# Access Compliance Report

## Public Rights-of-Way

Intersection ID: 10032188	Main Street: MORRISON_BV	Cross Street: N/A	Location: NE
ADA ID: 6C08B894CE61	Ramp Type: Perp	Initial Pass/Fail: Fail	Overall Compliance: No
Codes/Mitigation Info/Possible Solution		Field Measurements/Component Compliance	
Severity Score: 13.75

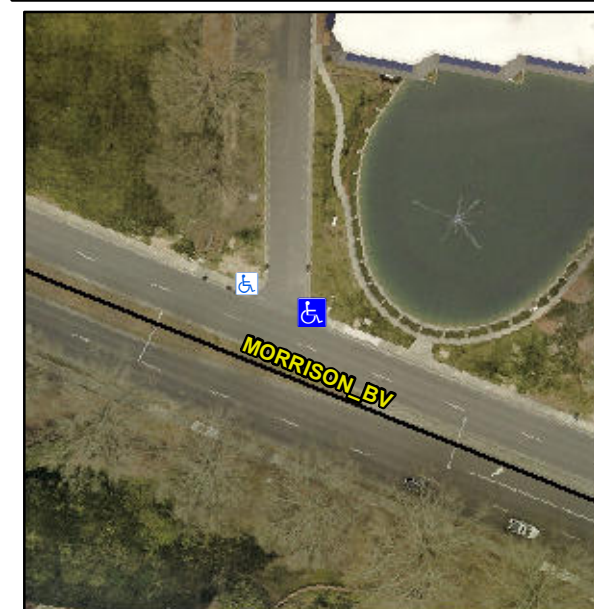
**Not Found, R304.2.2, R304.5.3**

Compliance	Description	Data	Compliance	Description	Data
N/A	Ramp Length (in)	48.0	No	Ramp Slope (%)	10.8
Yes	Ramp Width (in)	48.0	No	Ramp XSlope (%)	4.2
N/A	Flare Type LT	N/A	N/A	Flare Type RT	N/A
N/A	Flare Slope LT (%)	N/A	N/A	Flare Slope RT (%)	N/A
N/A	Flare Traversable LT?	N/A	N/A	Flare Traversable RT?	N/A
N/A	Landing Length (in)	N/A	N/A	DWS Provided?	N/A
N/A	Landing Width (in)	N/A	N/A	DWS Contrast?	N/A
N/A	Landing Slope (%)	N/A	N/A	DWS Length (in)	N/A
N/A	Landing X Slope (%)	N/A	N/A	DWS Full Width?	N/A
N/A	Landing Curb? (Y/N)	N/A	N/A	DWS Offset (in)	N/A
N/A	Shared Landing?	N/A			
N/A	Gutter Ponding?	N/A	N/A	Gutter Slope (%)	N/A
N/A	Gutter Lip Ht (in)	N/A	N/A	Gutter X Slope (%)	N/A
N/A	Painted X Walk1?	No	N/A	Painted X Walk2?	N/A
	X Walk 1 Direction	To NW		X Walk 2 Direction	N/A
N/A	X Walk 1 Width (in)	N/A	N/A	X Walk 2 Width (in)	N/A
	X Walk 1 Slope (%)	0.2		X Walk 2 Slope (%)	N/A
	X Walk 1 X Slope (%)	0.7		X Walk 2 X Slope (%)	N/A

**Remove & Replace Entire Ramp.**
